Rezoning Transportation Analysis
Petition Number: Insert Zoning Petition #2021-201
General Location Identifier: Tax ID 12709305

Revision Log:

Date	Description
12-23-21	First Review (WB)

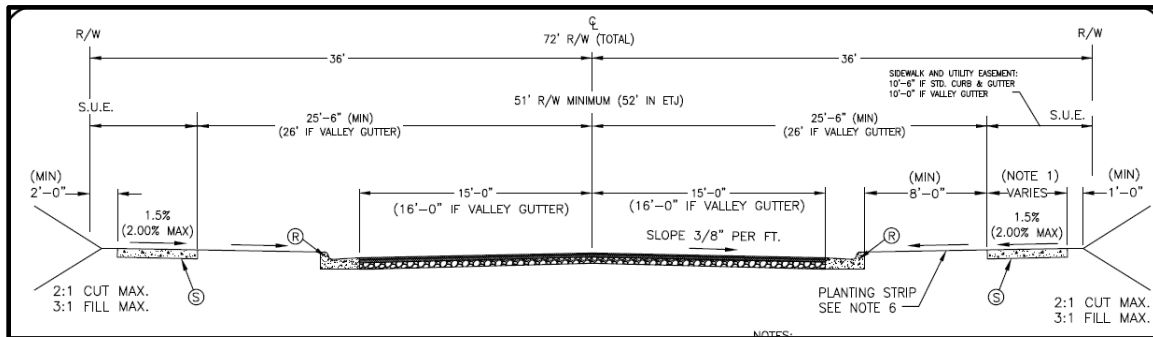
- Curbline:** The proposed zoning district has a setback measured from back of the existing or proposed future curbline.
 - Weddington Avenue:** The curb line will remain in its current location.
 - Bascom Street:** The curb line will remain in its current location.

Label and dimension the curb and gutter from the centerline for each road on the site plan.

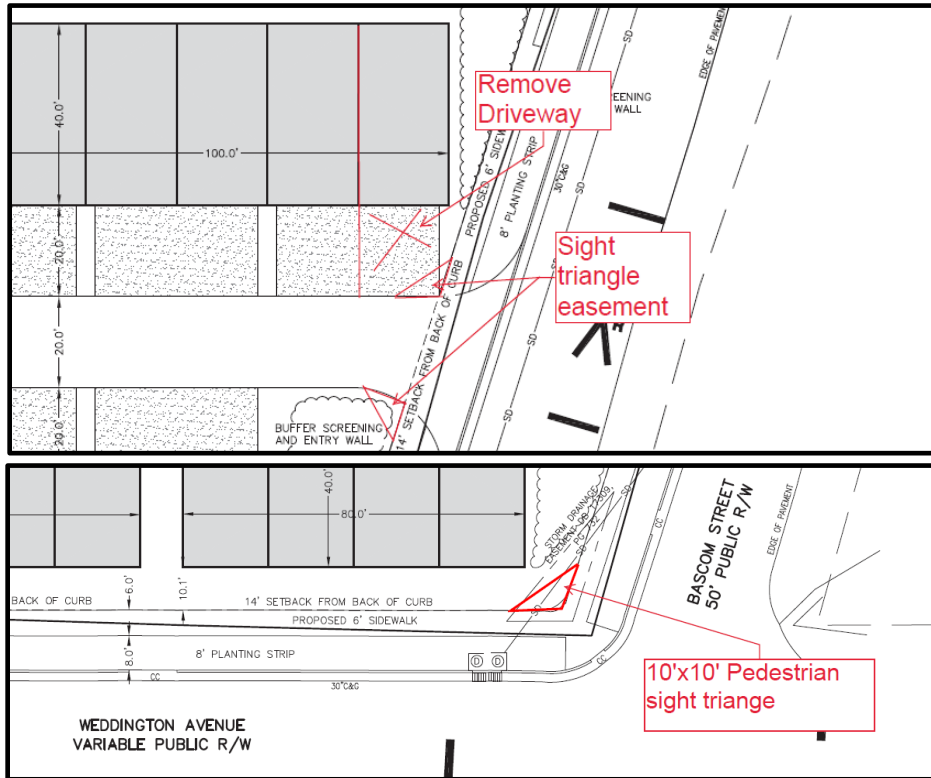
- Site plan and conditional notes revisions are needed to provide 10' x 10' pedestrian sight distance easements for any portion of the pedestrian sight triangles located outside the right-of-way and within

the development. Remove proposed driveway from the pedestrian sight triangle. The pedestrian triangle measures 10 feet x 10 feet with one leg measured along the back-of-sidewalk or right-of-way (whichever is the greater distance from the curb line) and the other leg measured along the driveway face-of-curb or edge-of-pavement. Also provide Pedestrian sight triangles at the intersection of Weddington Avenue and Bascom Street.

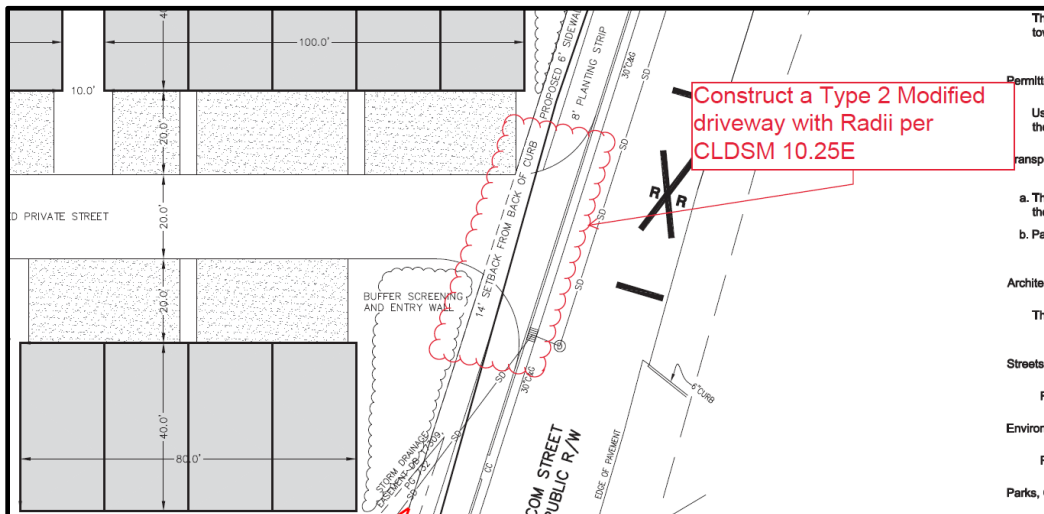
- Site plan revisions are needed to construct a CDOT standard driveway per CLDSM 10.25E. Proposed radii must match the City standards.

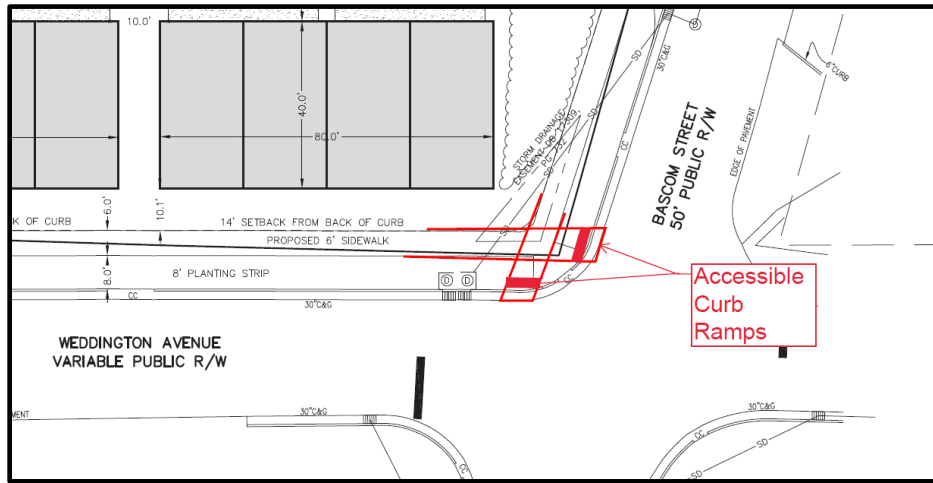
7. Revise Site plan to construct two (2) accessible curb ramps at the intersection per PROWAG and ADA law.
